Change Order

North Hardin High School Renovation
North Hardin High School
801 S. Logsdon Parkway
Radeliff, Kentucky 40160

CHANGE ORDER NUMBER: 004

Itemization of Change Order #4

ASI #6

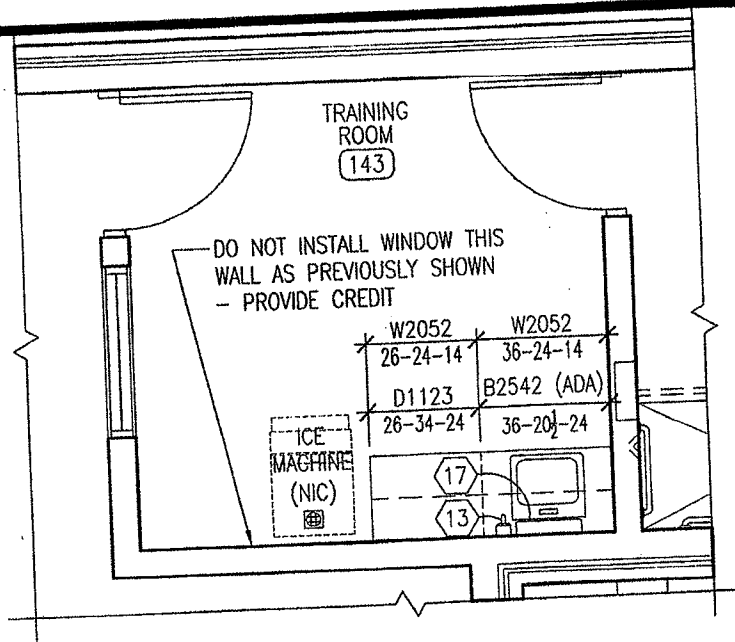
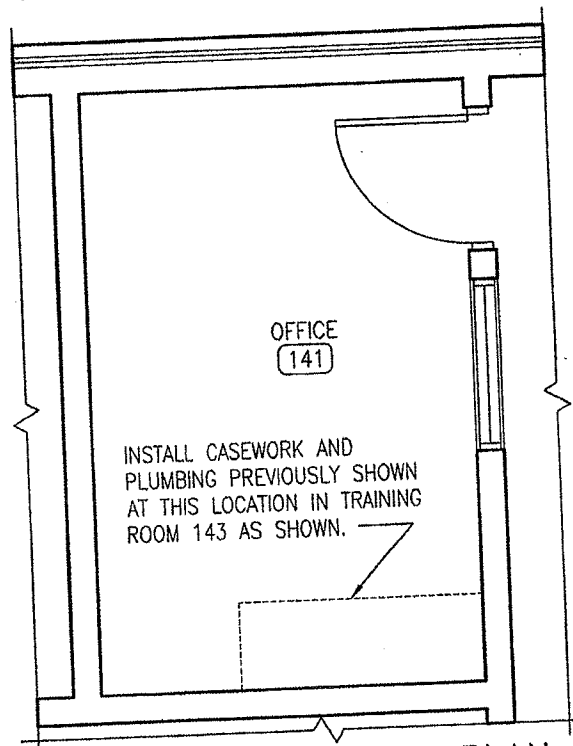
Refer to the attached drawings for revisions to Office 143 and Training Room 141. Plumbing revisions include installing sink S3A, and adding new FD1F and IMB in relocated Training Room 143.

1. THE PURPOSE OF THIS ASI IS TO REVERSE THE FUNCTIONS OF OFFICE 143 AND TRAINING ROOM 141. THE ROOMS SHALL BE RENAMED TO OFFICE 141 AND TRAINING ROOM 143.
2. ALL EQUIPMENT, PLUMBING, CASEWORK, ETC. PREVIOUSLY SHOWN IN ROOM 141 SHALL BE INSTALLED IN ROOM 143. REFER TO M/P/E ASI DRAWINGS FOR FURTHER REQUIREMENTS.
3. REFER TO BID DRAWINGS FOR DIMENSIONS, TAGS AND NOTES NOT SHOWN ON THIS SHEET.
4. ICE MACHINE (N.I.C.) SHALL BE INSTALLED IN TRAINING ROOM 143 AS SHOWN. REFER TO M/P/E ASI DRAWINGS FOR FURTHER REQUIREMENTS.
